HISTORIC AND DESIGN REVIEW COMMISSION

HDRC CASE NO: 2016-170
ADDRESS: 2220 W HUISACHE AVE
LEGAL DESCRIPTION: NCB 6828 BLK 0 LOT W 30 FT OF 19 E 30 FT OF 20
ZONING: R6 H
CITY COUNCIL DIST.: 7
DISTRICT: Monticello Park Historic District
APPLICANT: David McKay/Painting N Moore
OWNER: David McKay/Painting N Moore
TYPE OF WORK: Addition, alter front facade
REQUEST:

The applicant is requesting a Certificate of Appropriateness for approval to:

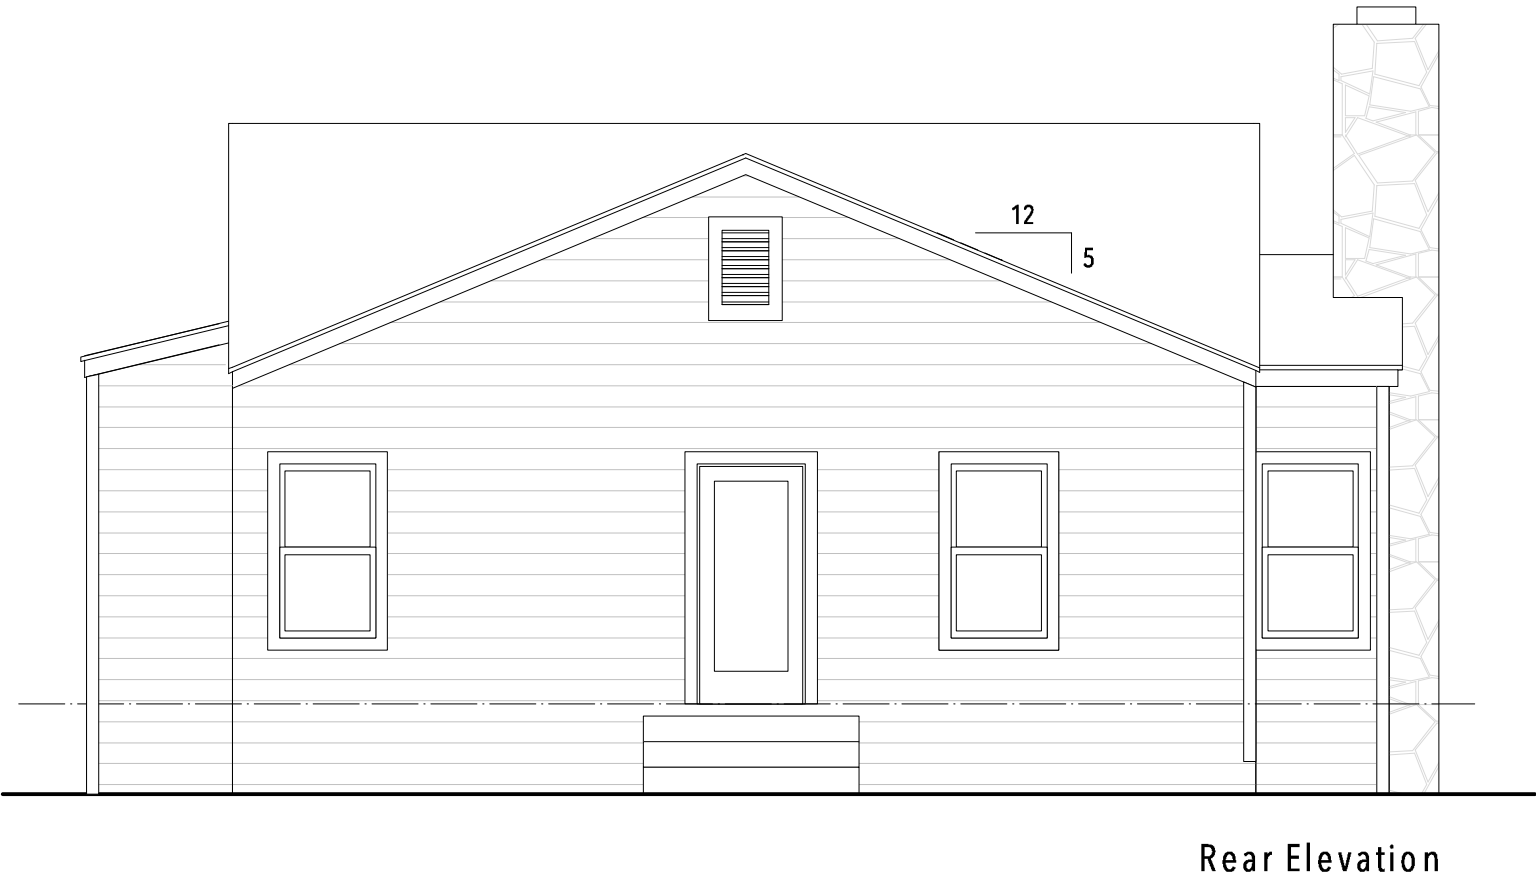
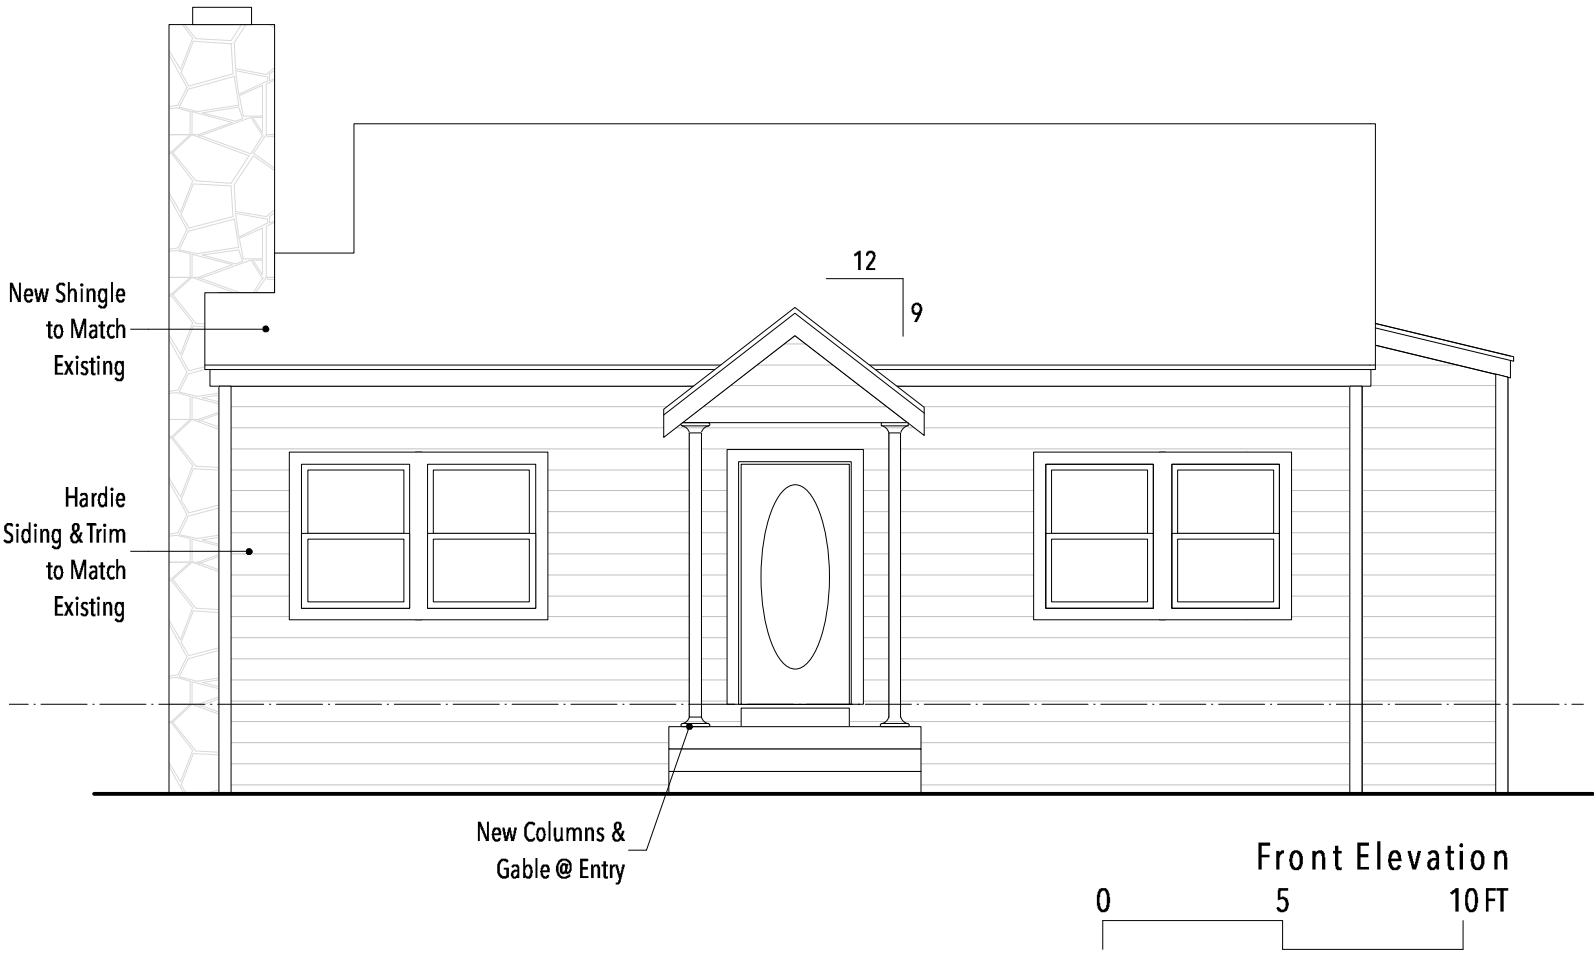
- c. **MASSING** - Guidelines for Additions recommend additions be subordinate to the historic structure. Due to its placement at the rear of the house, the proposed addition will be minimally visible from the street consistent with the Guidelines for additions 1.A.i.

- d. **ROOF FORM** - The existing structure is side-gabled, with an additional rear gable. The applicant is proposing to extend the rear gable, keeping the existing ridge height rear gable, keeping the existing rear gable intact. This is consistent with the Guidelines for Additions 1.A.iii. Staff has requested a roof form plan from the applicant, however it has not been submitted at this time.

- e. **TRANSITION** - A transition between the primary historic structure and the addition is needed in order to differentiate the addition from the existing structure. The applicant is proposing to create a vertical line with a 1" x 4" on both facades. This is consistent with the Guidelines.

- f. **FENESTRATION** – The applicant is proposing to add a door and a small one over one 2'x1' window on the left façade of the addition and two one over one windows. These windows match the proportions of existing windows. No openings are being proposed on the right elevation of the addition. This is consistent with Guidelines for Additions 4.

- g. **MATERIALS** – The proposed siding material of hardie board to match the dimensions of the existing wood siding that is consistent with the Guidelines for Additions 3.A.i.

Staff recommends approval of the items #1 through #3 based on findings a through i with the following stipulations:

Existing Deatched Garage

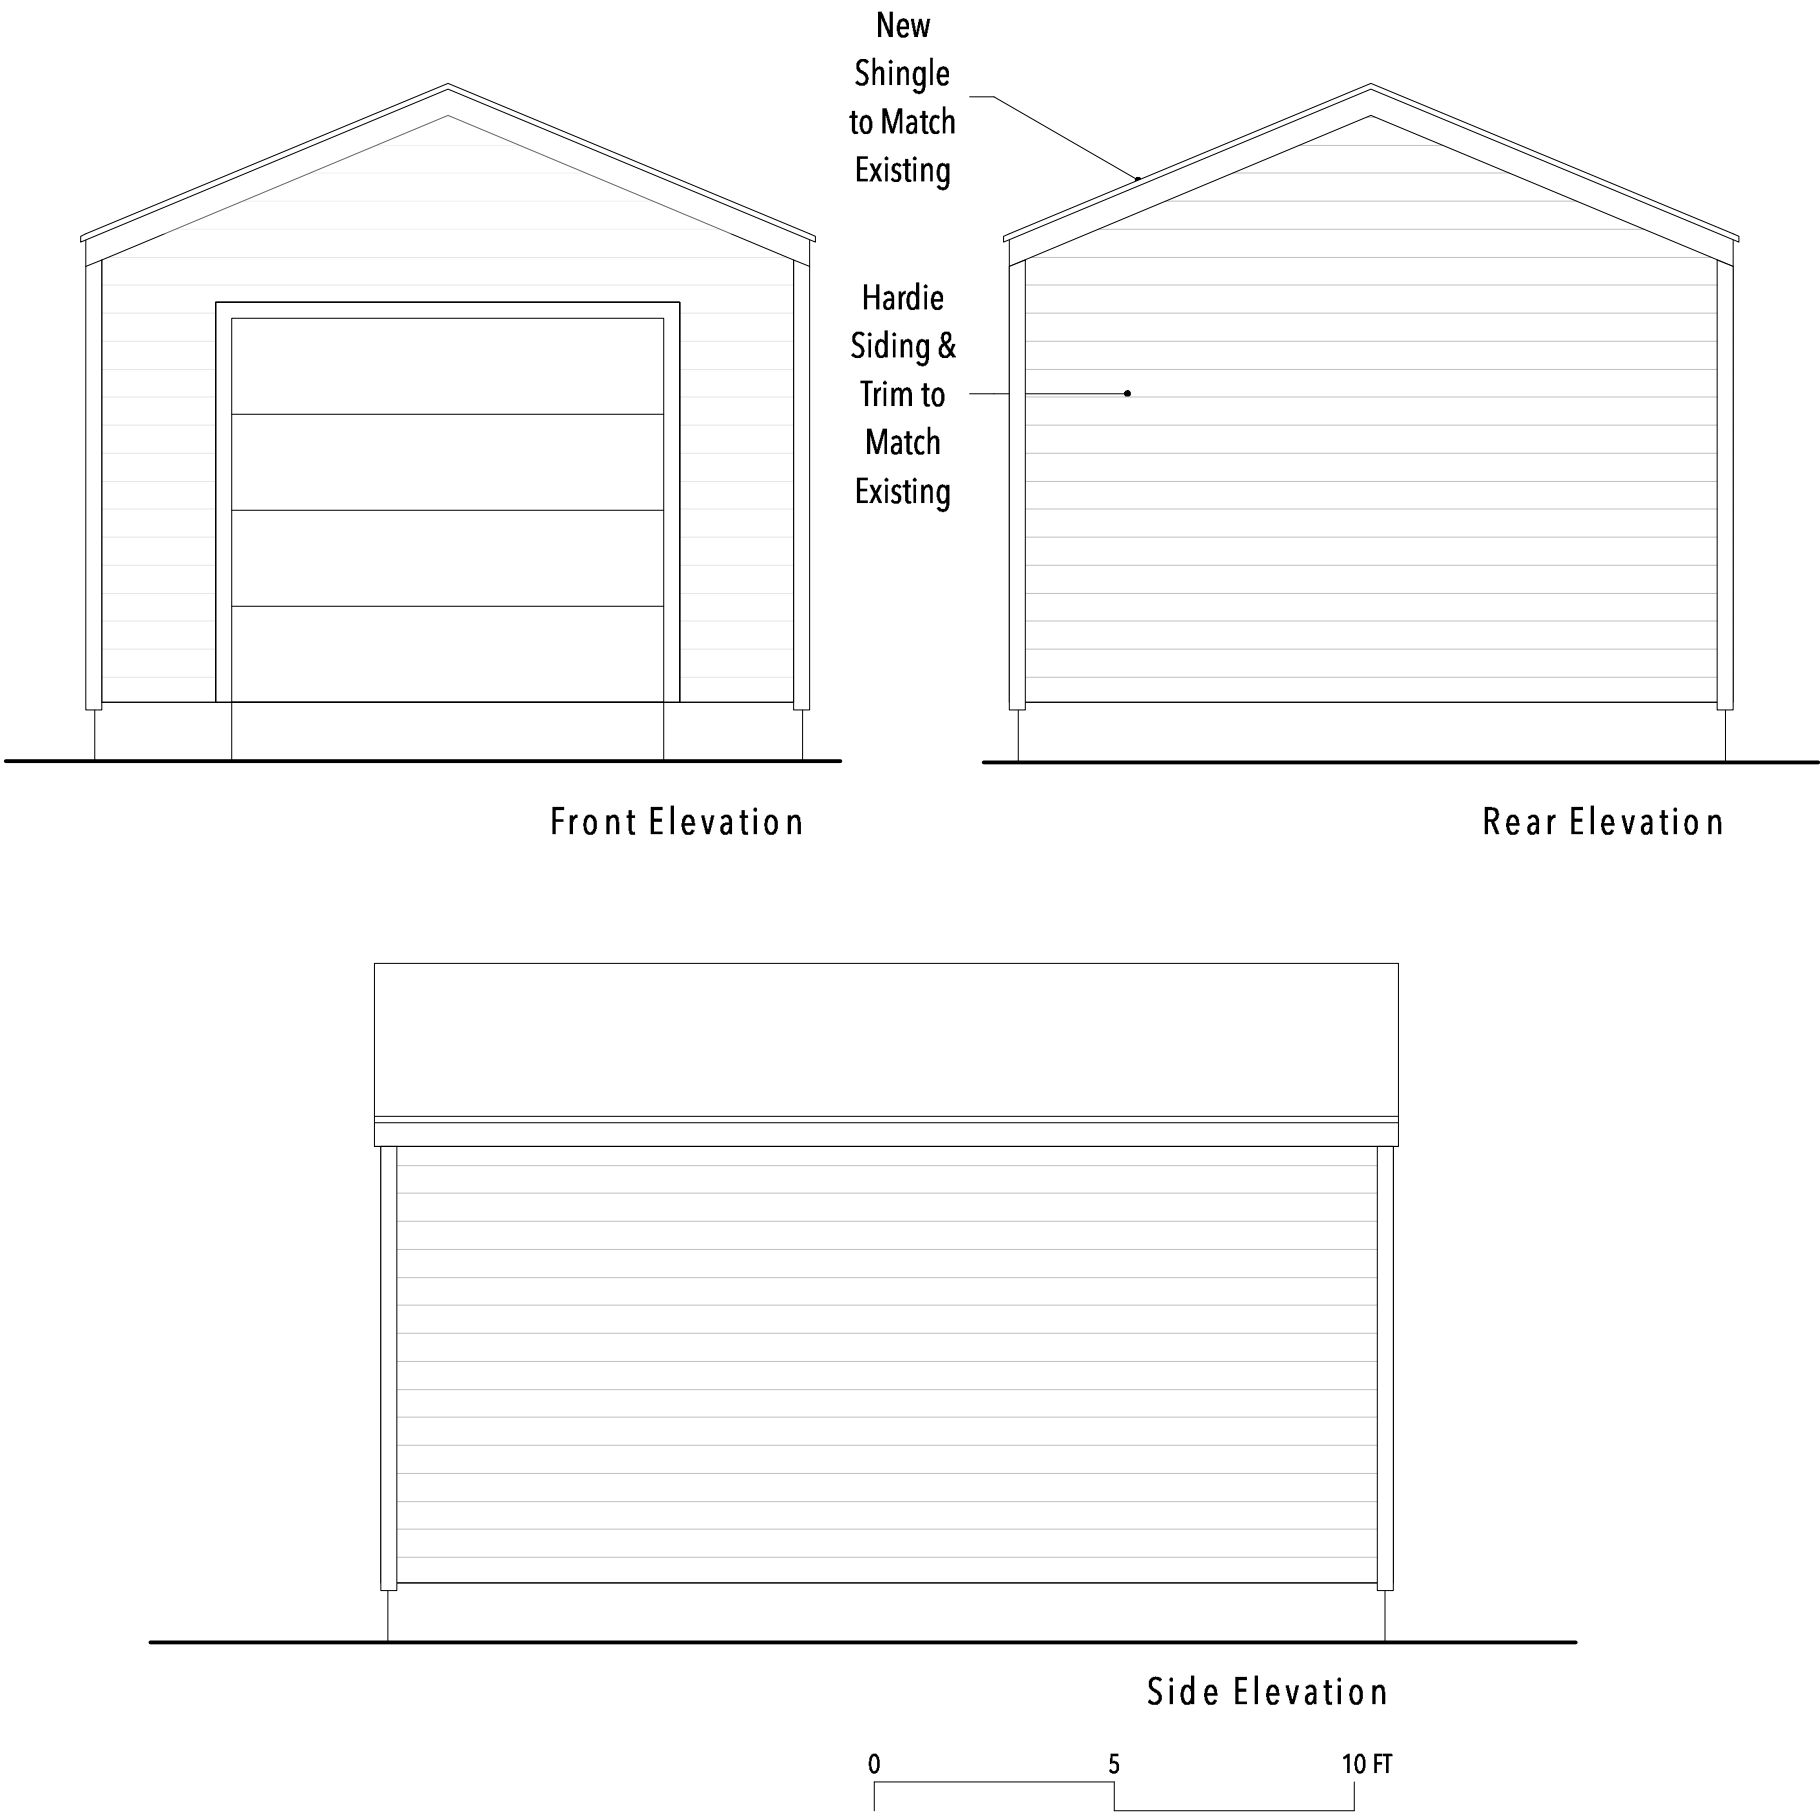
- h. **GARAGE ROOF** – There is an existing un-finished garage at the rear of the property with no roof, wood siding, garage door opening and an aluminum window on the left elevation. The proposed gable roof with composition shingle roof is consistent with the Guidelines for New Construction 5.A.iii, that indicates new garages should relate to the primary structure.

- i. **GARAGE** - The applicant has proposed to enclose the existing window opening and install a new garage door with now window lites, however one façade drawing and garage door specifications are missing. Staff has requested this elevation drawing from the applicant, however it has not been submitted at this time.

1. That the applicant install a wooden garage door and provide details to staff before receiving a Certificate of

2. That the applicant provide the missing side façade elevation of the garage to staff.
3. That the applicant provide a roof form plan.
